A REPAIR

ON-SITE SEWAGE DISPOSAL SYSTEM HOWARD COUNTY HEALTH DEPARTMENT BUREAU OF ENVIRONMENTAL HEALTH

SUBDIVISION: Glenwood Springs LOT NUMBER: 46

ADDRESS: 2823 Saddlebred Court PROPERTY OWNER: Christ

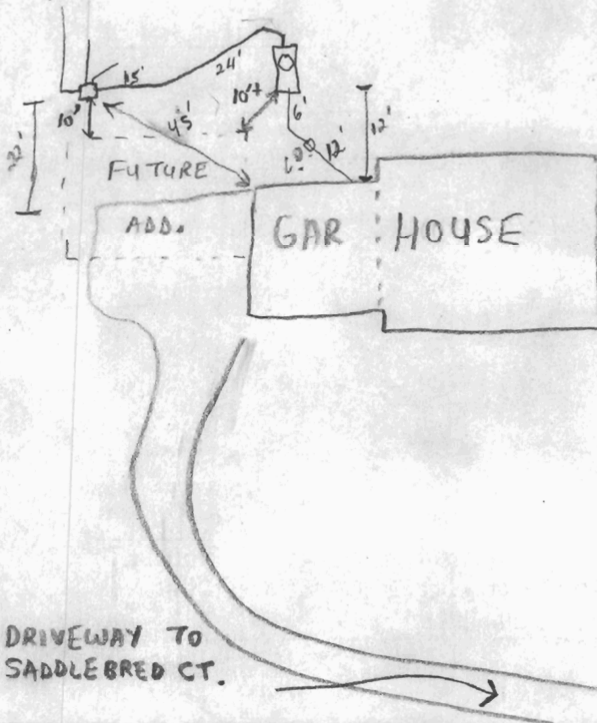
PRE-CONSTRUCTION INSPECTION: 1/4/02 - REPL. TANK W/ NEW 1500 T.S. 10' AWAY FROM FUTURE ADDITION, OK TO LEAVE EX. SYSTEM AS IS, ADDITION IS ONLY 1 BR AND INITIAL SYSTEM SIZED FOR 5 BEDROOM GIVEN PERC RATE OF 180 GPD NOT 240 GPD. D.B. & EY TRENCHES MAY BE LESS THAN 20' TO NEW ADDITION BUT NEW ADDITION NOT TO BE ON FOUNDATION, PLENTY OF AREA EXISTS FOR FUTURE REPAIRS (SRK)

1/9/02 Work per layout. Use current D.B., appears in good condition w/ good leachings. Need to replace baffle in D.B.

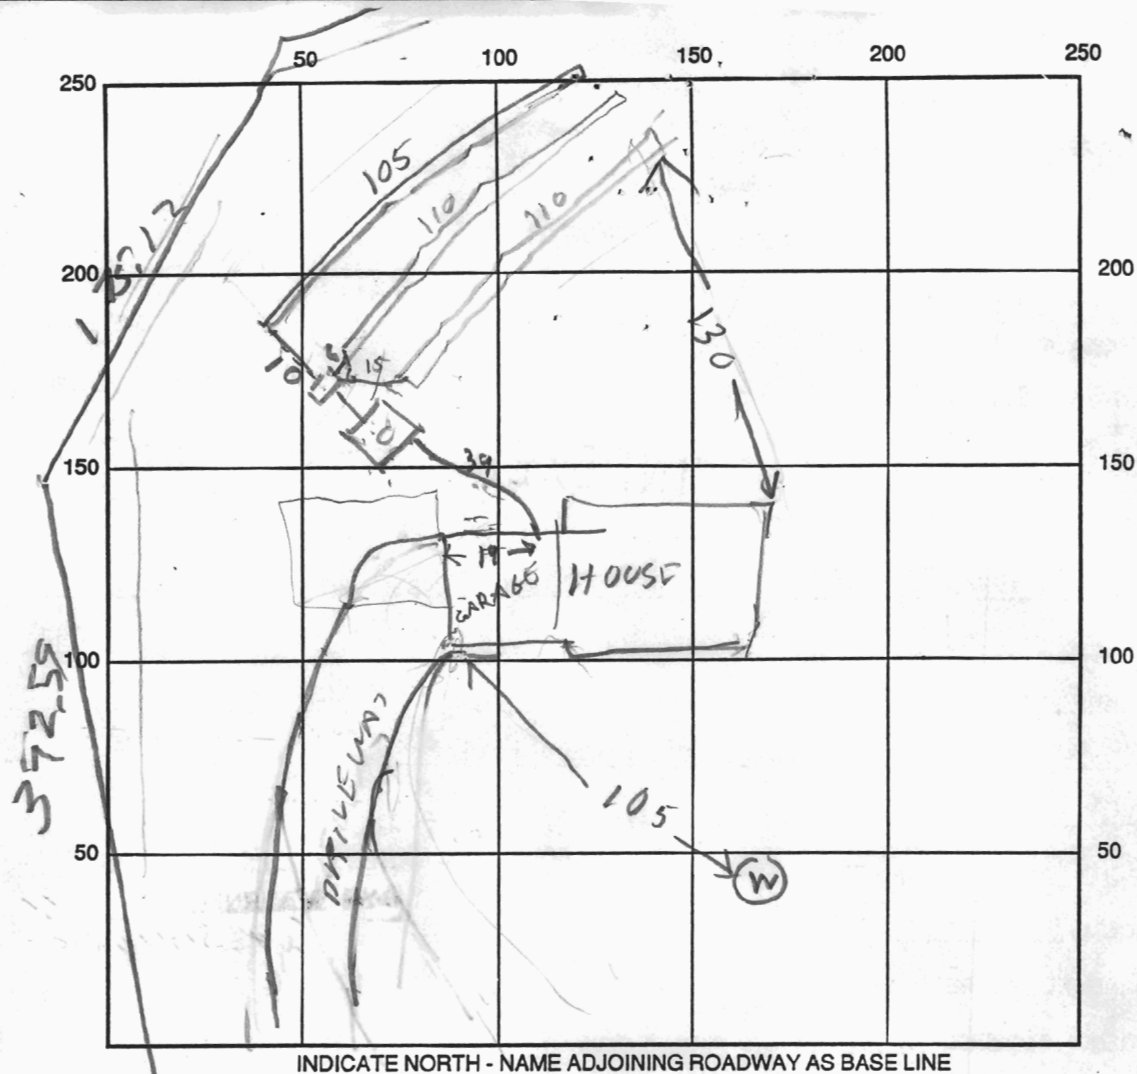
REMARKS: 9/5/90 AM - LOCATION OK TANK OK TRENCH #1 DUG, NO STONE R11

9/6/90 - TRENCHES OK
